Project Location:	0 Mandela Parkway. The vacant parcel is located across from the neighboring property at 3650 Mandela Parkway and next to Beach Street and Target store.
Assessor's Parcel No:	007 061701405
Development Proposal:	To construct a six-story building "Mandela Hotel" consisting of 220 rooms measuring approximately 142,813 square feet of floor area with two-levels of underground parking garage and a small open parking area totaling 166 parking spaces.
Project Applicant / Phone Number:	Joanne Park, lead architect for Architectural Dimensions / (510) 463-8300
Hotel Operators:	Tulsee Nathu & Payal Nathu
Property Owner:	State of California
Case File Number:	PLN16394
Planning Permits Required:	<ol style="list-style-type: none"> 1) Major Conditional Use Permit for non-residential projects with more than 25,000 square feet of floor area; 2) Minor Conditional Use Permits for transient habitation (Hotels) and non-residential tandem parking; 3) Regular Design Review for new building construction; and 4) Minor Variance for front yard setback reduction.

CITY OF OAKLAND PLANNING COMMISSION

Case File: PLN16394

Date: March 20, 2018
To: Mike Rivera, Project Case Planner
From: Sharon Wr

Comments/Concerns re: Mandela Parkway frontage

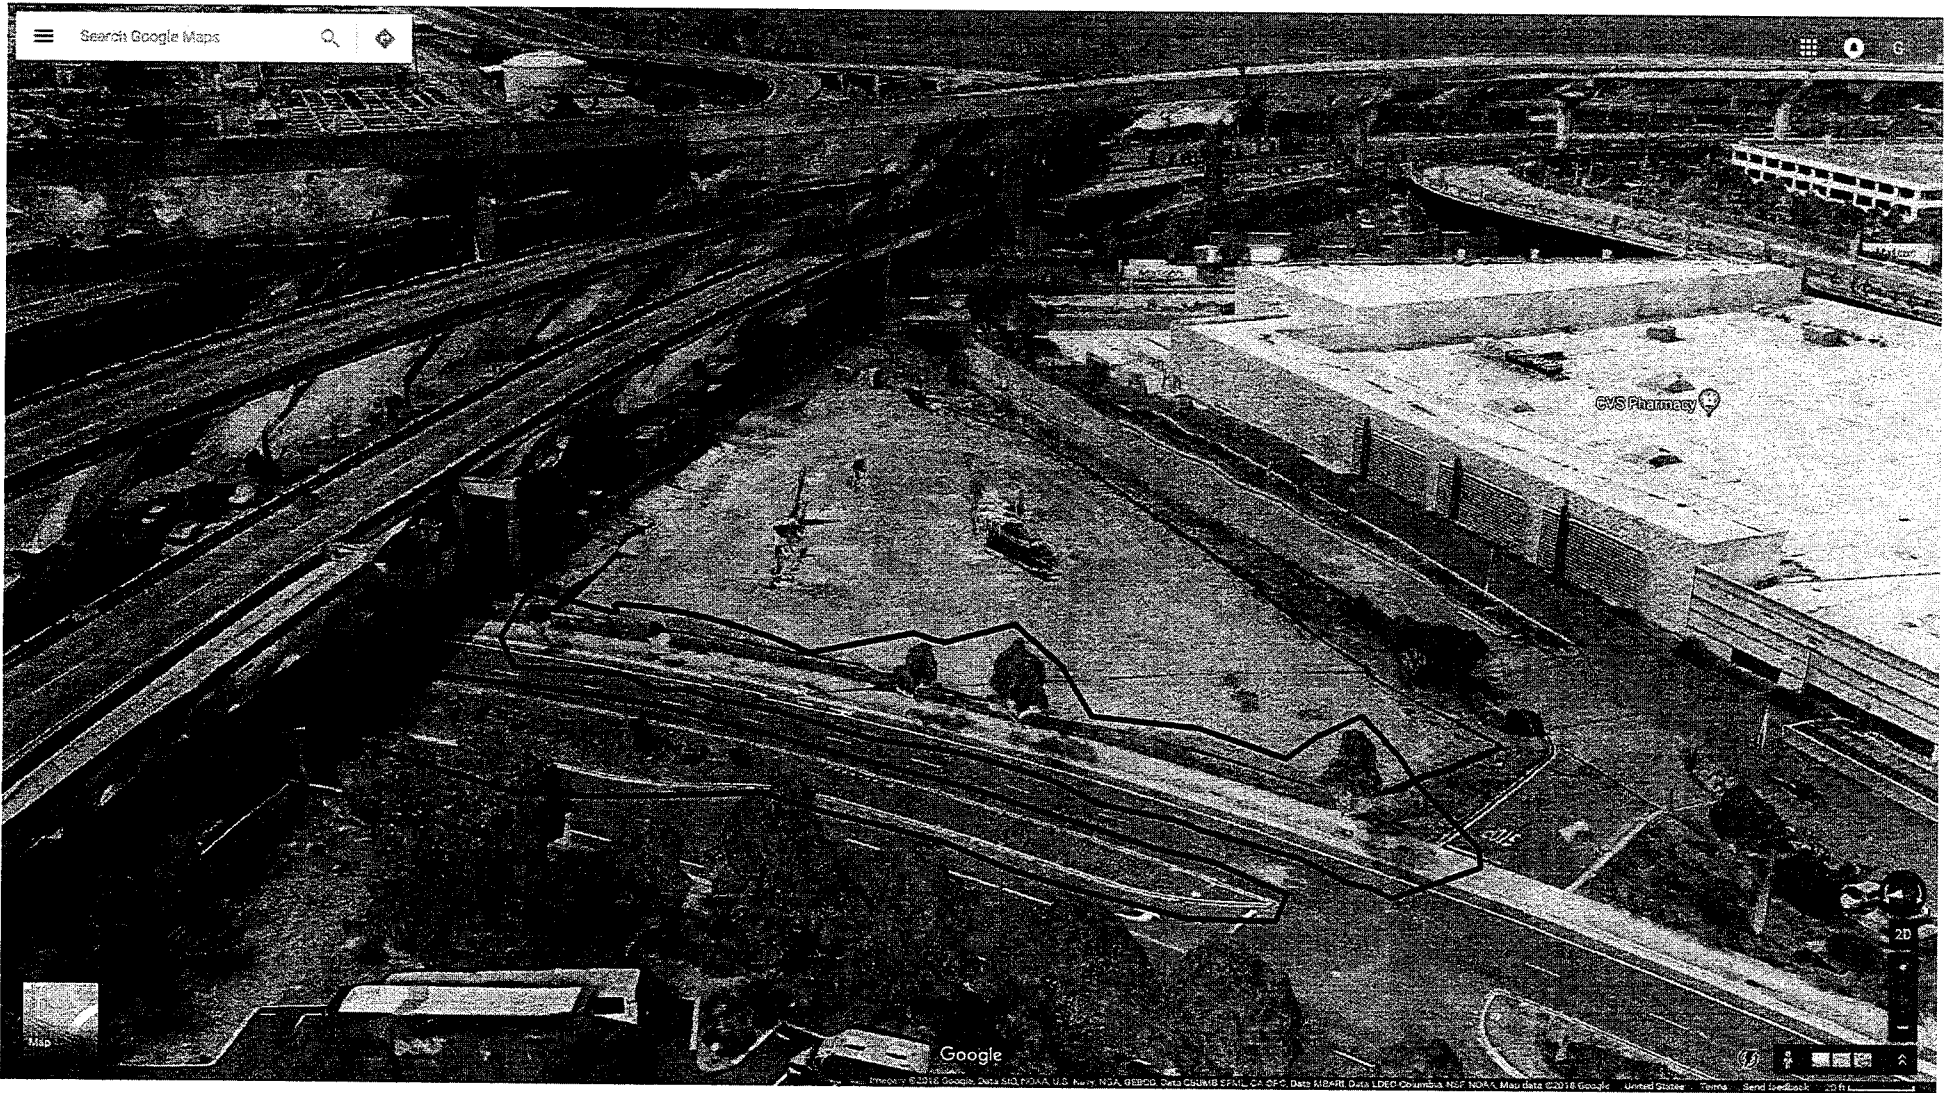
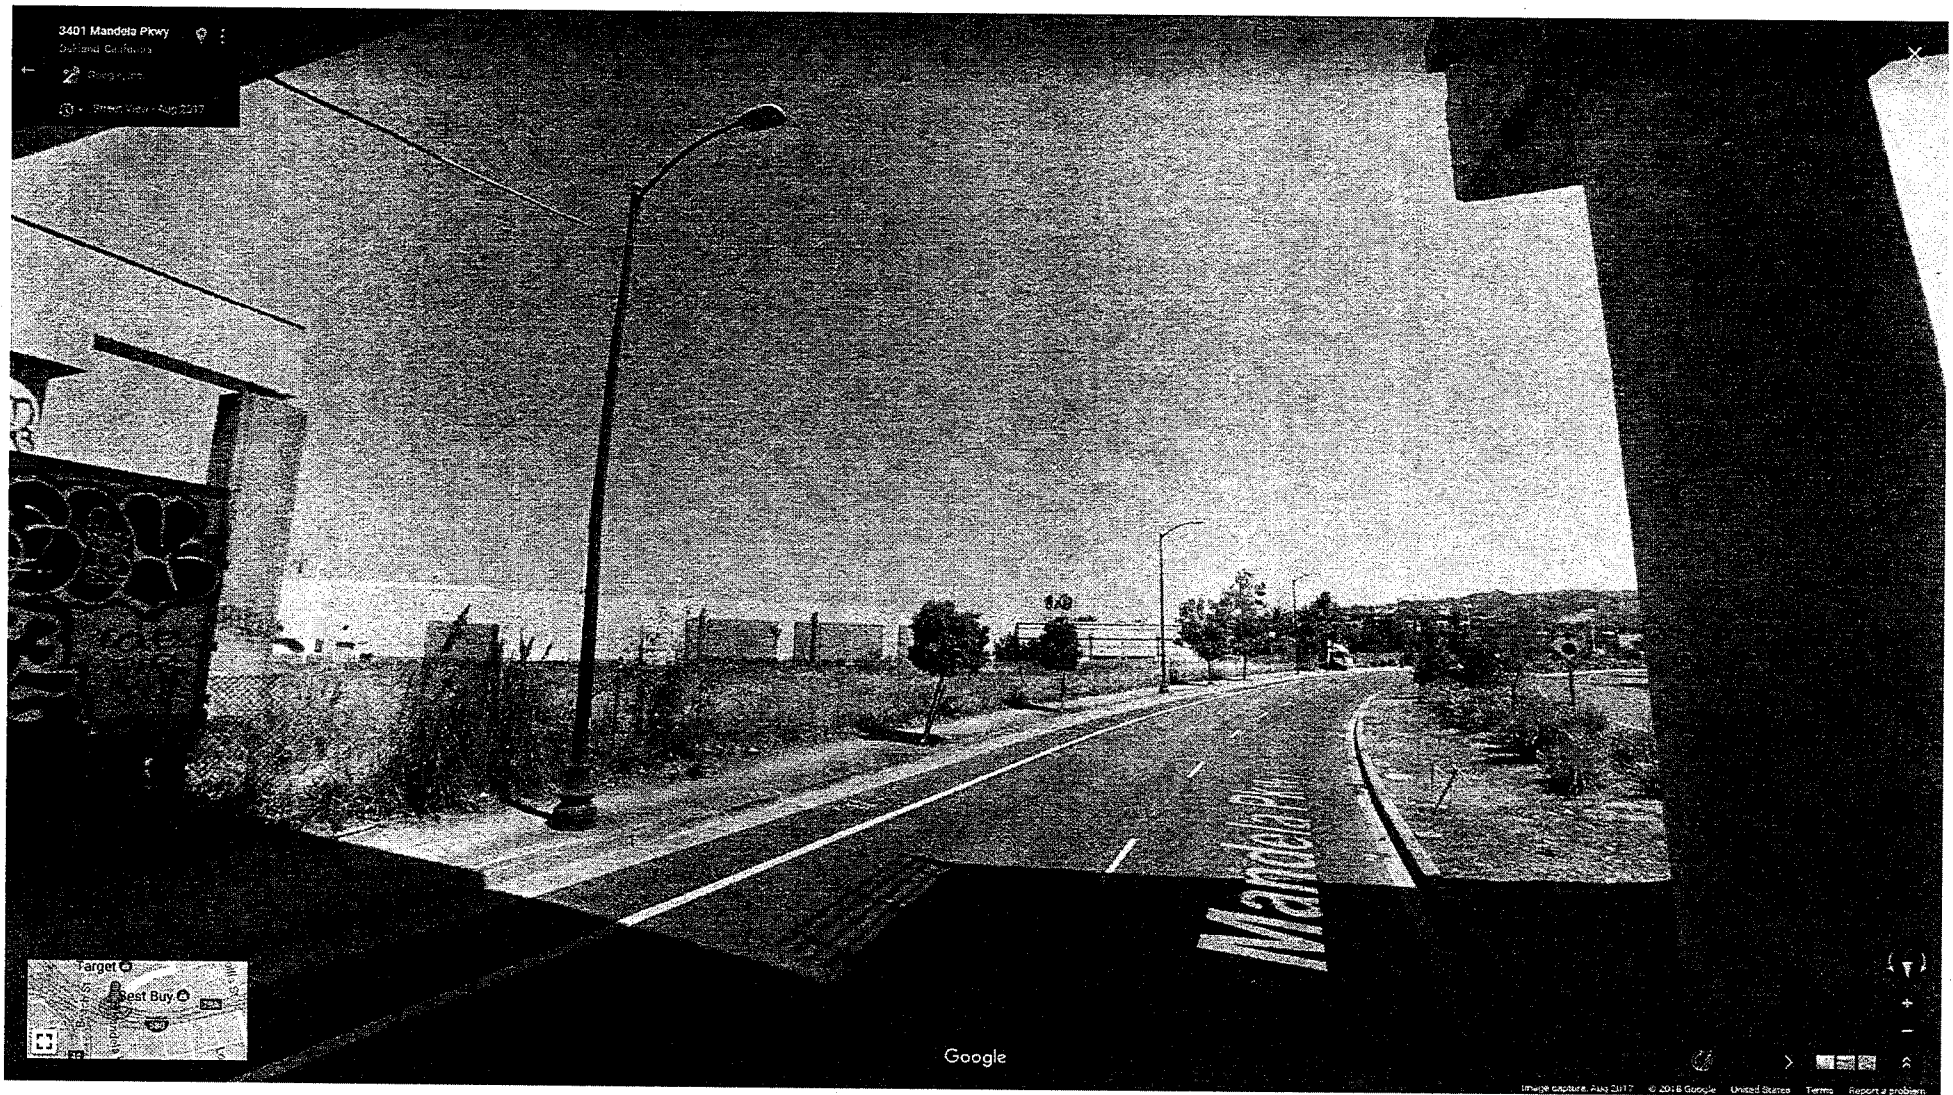
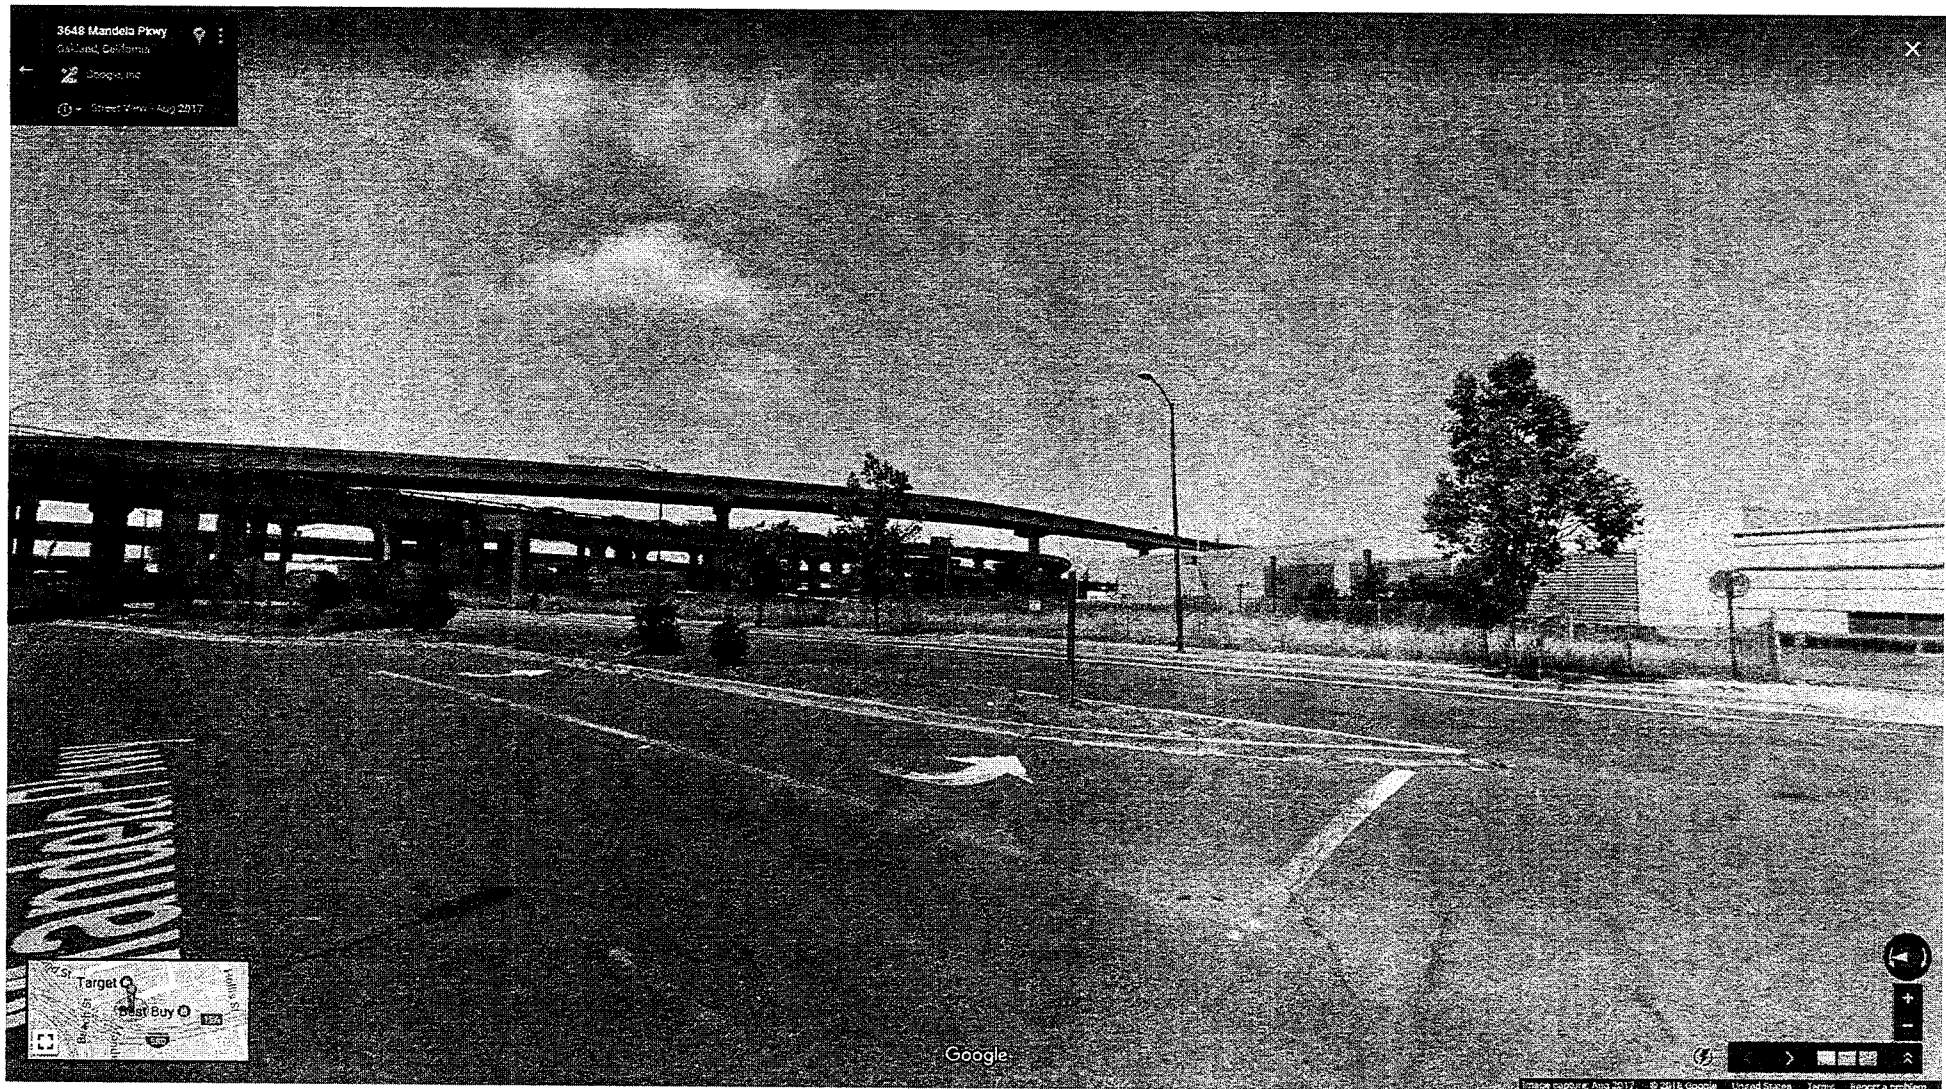
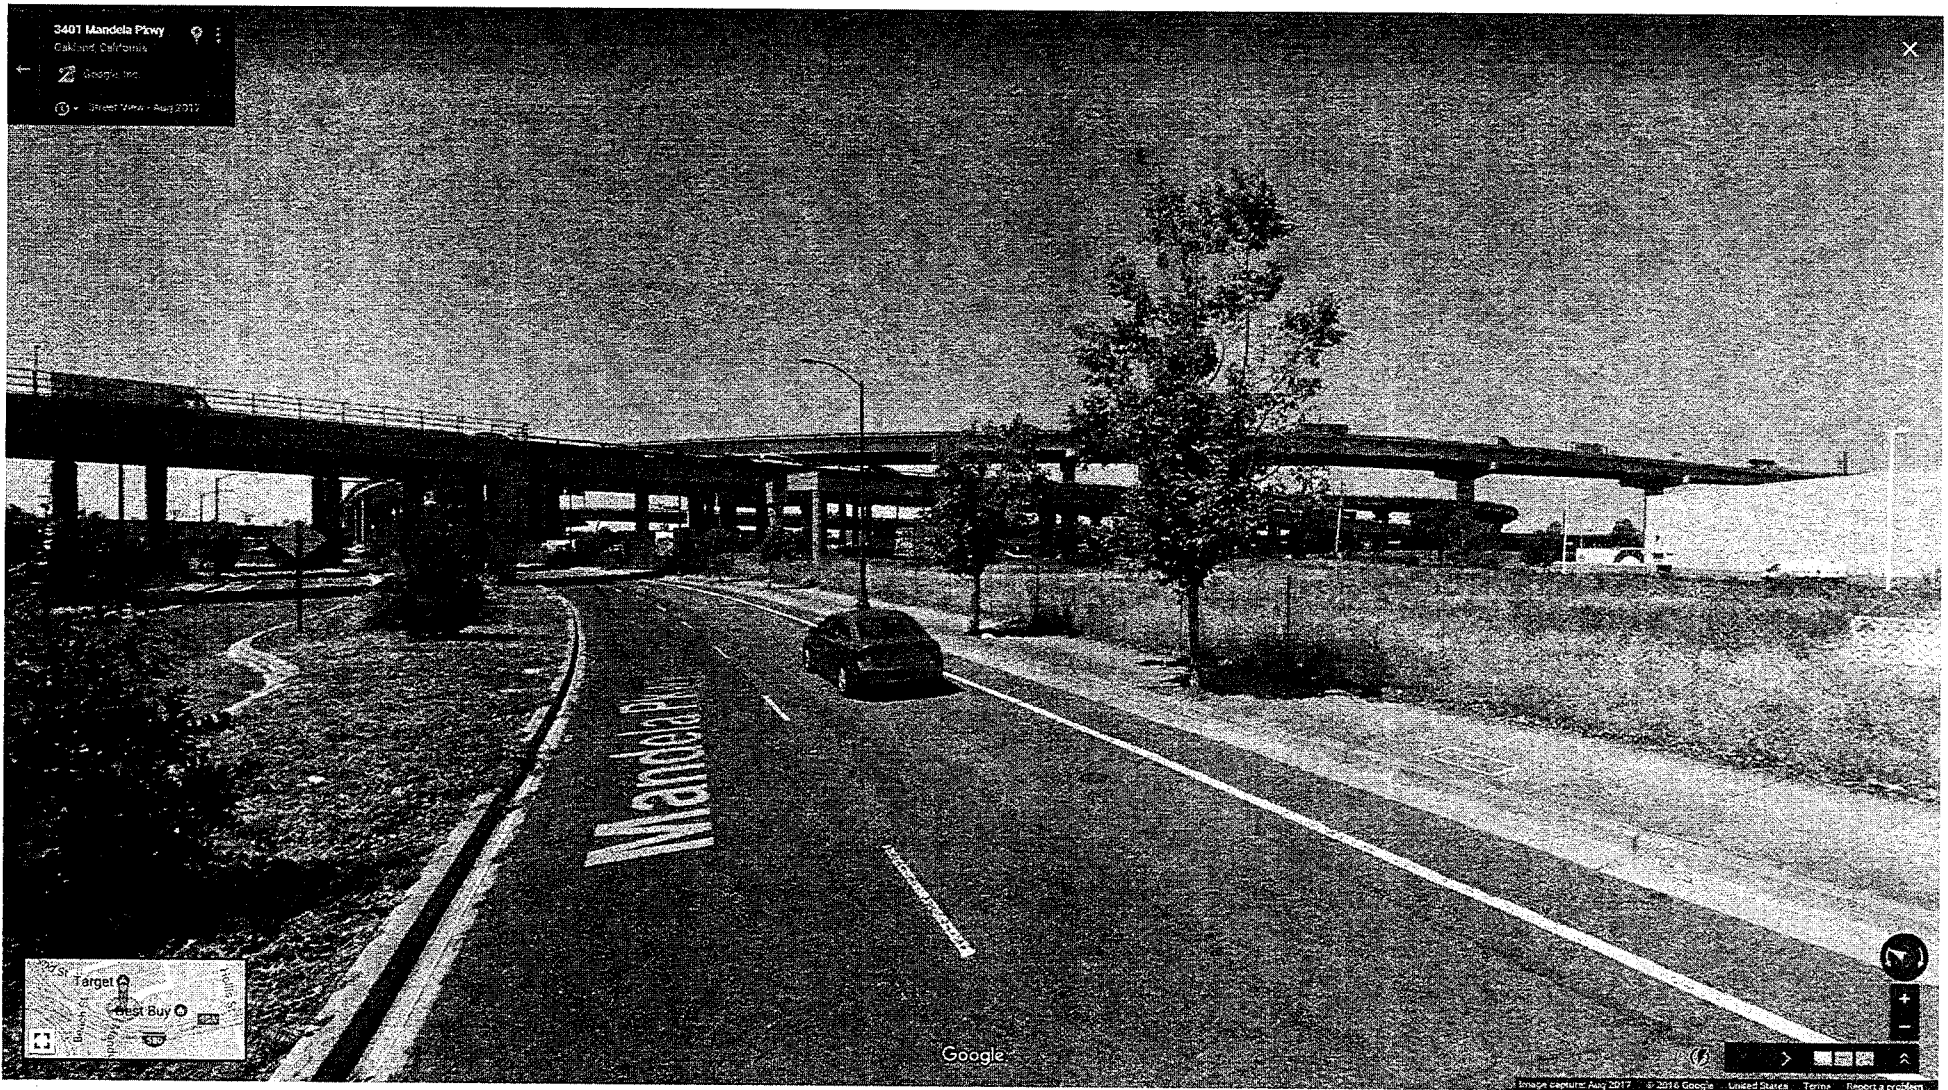
- These suggestions are made not to burden the developer; they are to ensure that the project's design take into account the real conditions of the public realm along the boulevard (e.g. problematic tendencies of dumping, vandalism, graffiti, etc., as well as scarce City resources for right-of-way landscape maintenance) and to ensure that it realizes benefits for both the community and for itself, as a welcome new neighbor, an important set of "eyes on the street" and in the neighborhood, a provider of jobs, a hospitable setting for pedestrians and users along Mandela Parkway, and a catalyst for investment and care along the corridor.

Note the existing sparse and stunted street tree canopy & landscape along the site's Mandela Parkway sidewalk and along the center median (outlined in red)

Note the existing sparse and stunted street tree canopy & landscape along the site's Mandela Parkway sidewalk and along the center median. Pedestrian buffering from cars/trucks is ineffectual. 5

Note the existing sparse and stunted street tree canopy & landscape along the site's Mandela Parkway sidewalk and along the center median. Pedestrian buffering from cars/trucks is ineffectual. 6

Note the existing sparse and stunted street tree canopy & landscape along the site's Mandela Parkway sidewalk and along the center median. Pedestrian buffering from cars/trucks is ineffectual. 7

Note the existing sparse and stunted street tree canopy & landscape along the site's Mandela Parkway sidewalk and along the center median. Pedestrian buffering from cars/trucks is ineffectual. 8
